MEMORANDUM

To: Site and Architectural Review Committee **Date:** January 22, 2020
From: Daniel Fama, Senior Planner *DF*
Via: Paul Kermoyan, Community Development Director *PK*
File No.: PLN2019-328 ~ Major Planned Development Permit Modification
Address: 100, 200, and 300 Haymarket Ct. (formally 880 and 910 Harriet Avenue)

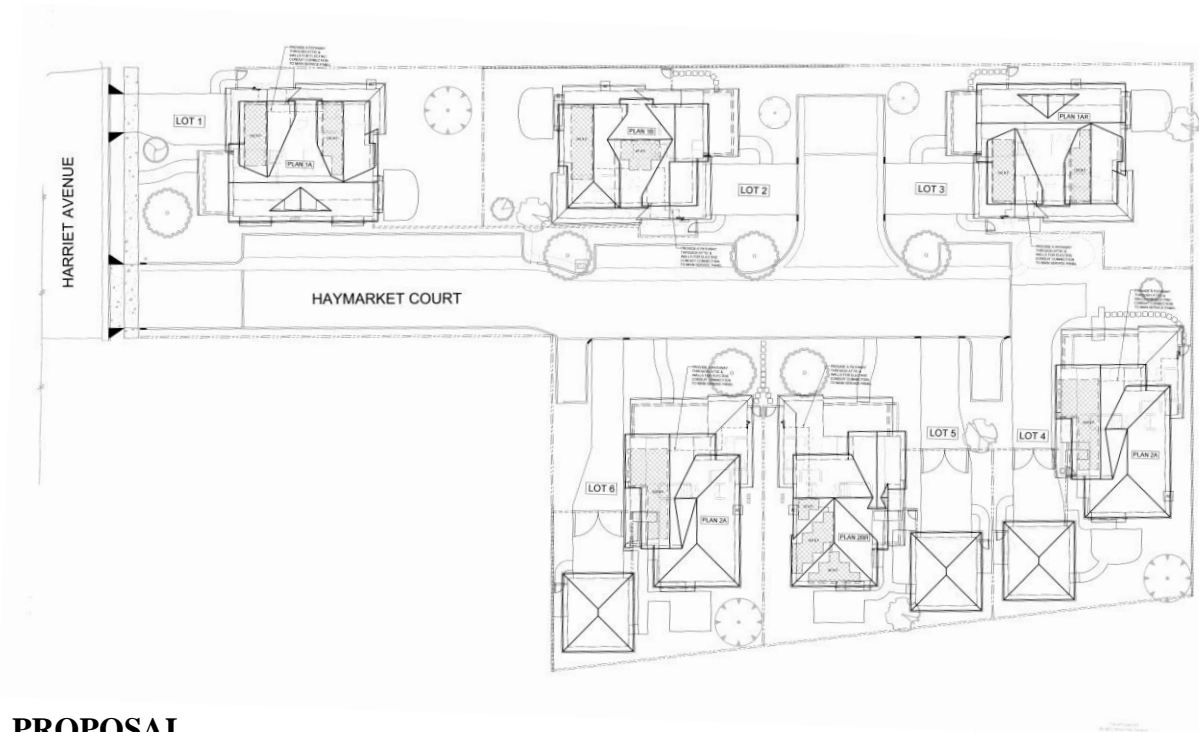
Design: The revised garage/ADU structures are shown below. The structures generally maintain design consistency with the primary homes (reference **Attachment 3** – Final Elevations), as required by the ADU Ordinance. However, staff has advised that the Lot 5 garage/ADU should incorporate shingled wall cladding to more closely match the architecture of the primary house.
